Name Of Dam: KEOKEE DAM  
Location: LEE COUNTY, VIRGINIA  
Inventory Number: VA 10502

# PHASE I INSPECTION REPORT NATIONAL DAM SAFETY PROGRAM

**PREPARED FOR**  
**NORFOLK DISTRICT CORPS OF ENGINEERS**  
**803 FRONT STREET**  
**NORFOLK, VIRGINIA 23510**

**BY**  
**GILBERT ASSOCIATES, INC.**

**STANDARD COVERED RISER**

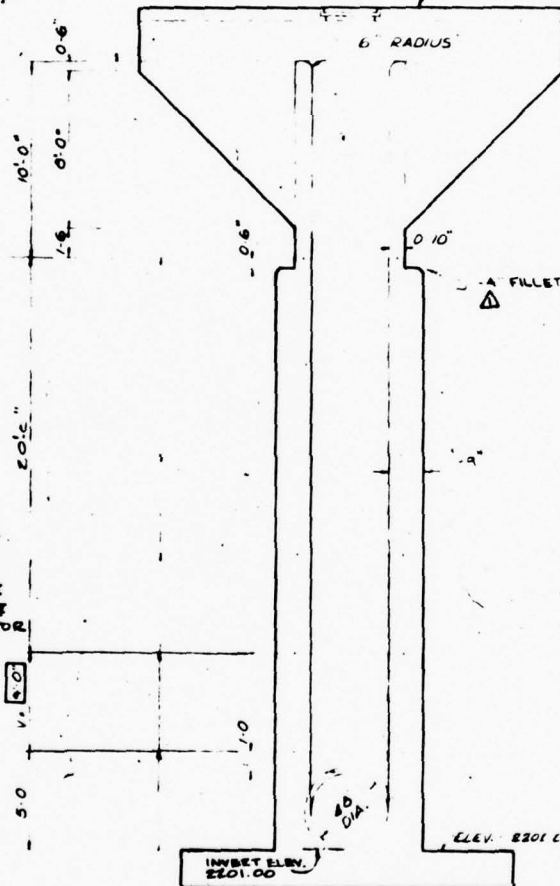
ADDENDUM MAY 16, 1979  
THE OUTSIDE FACE OF THE INTAKE RISER  
WAS REVISED TO ELIMINATE THE OFFSET.  
THIS REVISION IS SHOWN ON SHEET  
NO. 9, 10 & 11 OF THE PLANS. THE STEEL  
AND CONCRETE QUANTITIES AND THE  
STEEL SCHEDULE ON THIS SHEET HAVE  
NOT BEEN REVISED. THE CONTRACTOR  
SHALL SUBMIT SHOP DRAWINGS  
FOR THE REINFORCING STEEL.  
THE STEEL QUANTITIES WILL BE  
CHECKED AT THAT TIME.
